ZONING & VARIANCE PLAT
LOT 40, BLOCK "O"
HOLLYDALE, UNIT FOUR

PETITION NO: Z-75

ZONING COMMENTS:

Z-75 MARICEL G. VARGAS

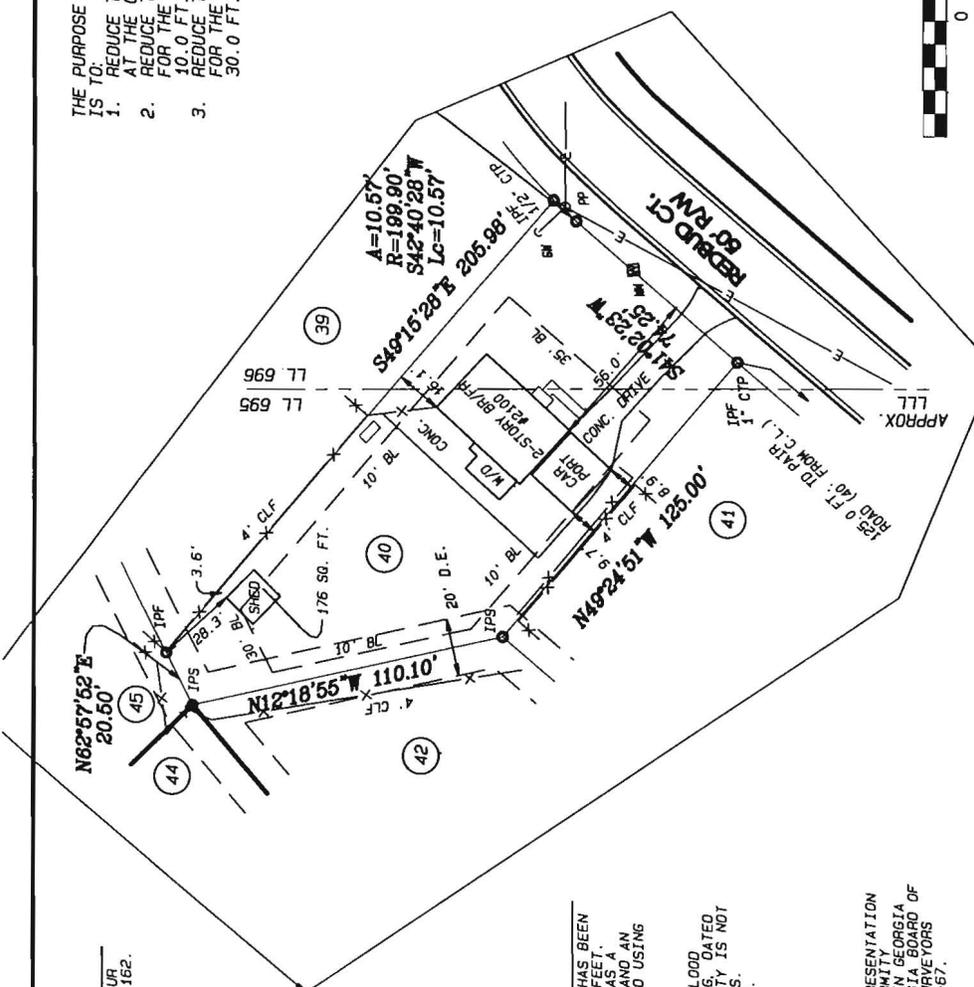
The applicant is requesting a rezoning from PSC (planned shopping center) and R-15 to R-15 in order to continue to use the property as a single family home. The applicant built an attached carport on the property without a permit and subsequently lost its grandfathered status. The applicant doesn't intend to do any other improvements.

1. Reduce side setback on the south easterly property line from 10 feet to 8.9 feet;
2. Reduce side setback on the north westerly property line from 10 feet to 3.6 feet;
3. Reduce rear setback from 30 feet to 28.3 feet.

Based on the above analysis, Staff recommends **APPROVAL** subject to the following conditions:

- Apply for permit for carport;
- Variances approved for existing buildings only, any new variances will go to the Board of Zoning Appeals;
- Water and Sewer Division comments and recommendations;
- Department of Transportation comments and recommendations; and
- Stormwater Management Division comments and recommendations;
- Development and Inspections comments and recommendations.
